# MICHALSKI & ASSOCIATES, INC.

March 18, 2013

**Re: Comments on Groundwater Issues of Site-Wide Permit Renewal  
CWM Chemical Services Model City Site, Model City, New York**

## **EXHIBIT 1**

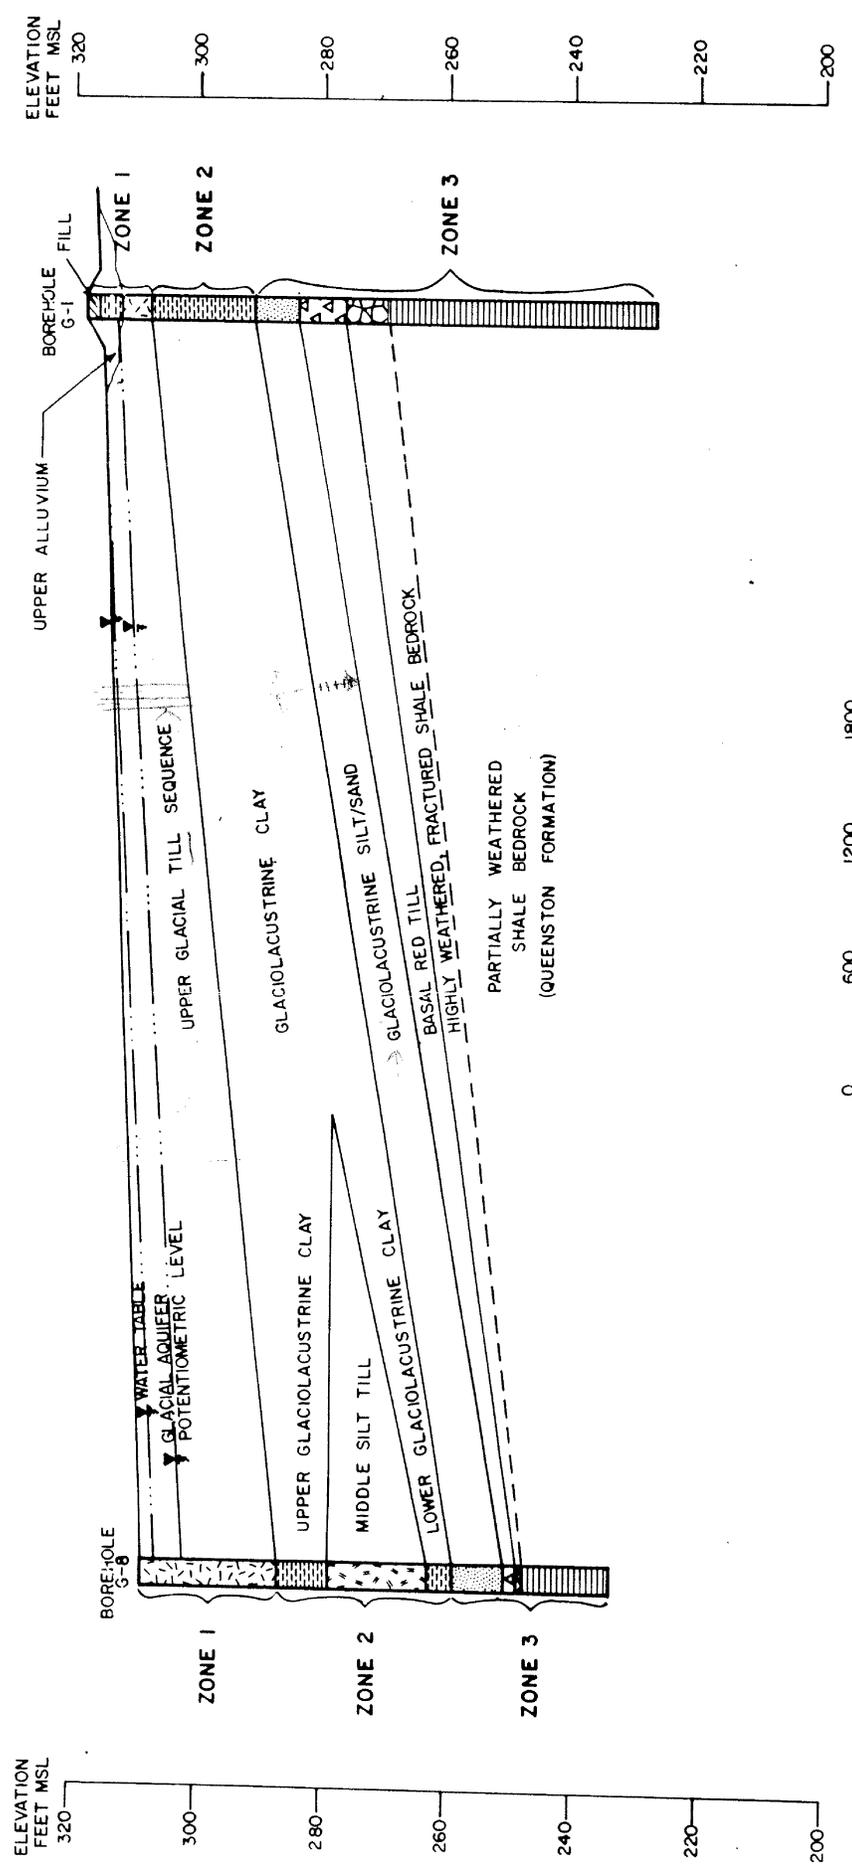
The conceptual hydrostratigraphic model of the site is based on a 27-year-old interpolation of conditions encountered in two boreholes located more than one mile apart. The model, presented in Figure 3 in Groundwater Sampling and Analysis Plan (Golder Assoc., 2009a) and attached herewith as Exhibit 1, was originally proposed by Golder Associates (1985), and was only slightly modified by Golder Associates (1993). Subsequent boring and well data have indicated substantial variability in thickness of the Upper Till Sequence, the Glaciolacustrine Clay, and the Middle Silt Units, and in the depth of the top of bedrock within the project area. However, these new data are not reflected on structural maps of individual hydrostratigraphic units of the model, and no updated cross-sections have been provided. Therefore, the presentation of site hydrogeologic conditions is overly simplistic and obsolete.

A much more detailed and robust graphical representation of site hydrological conditions is required under Part 360-2.11. CWM must provide maps depicting actual elevations of the top and bottom surfaces of the various units identified; the thickness of these units, or site cross-
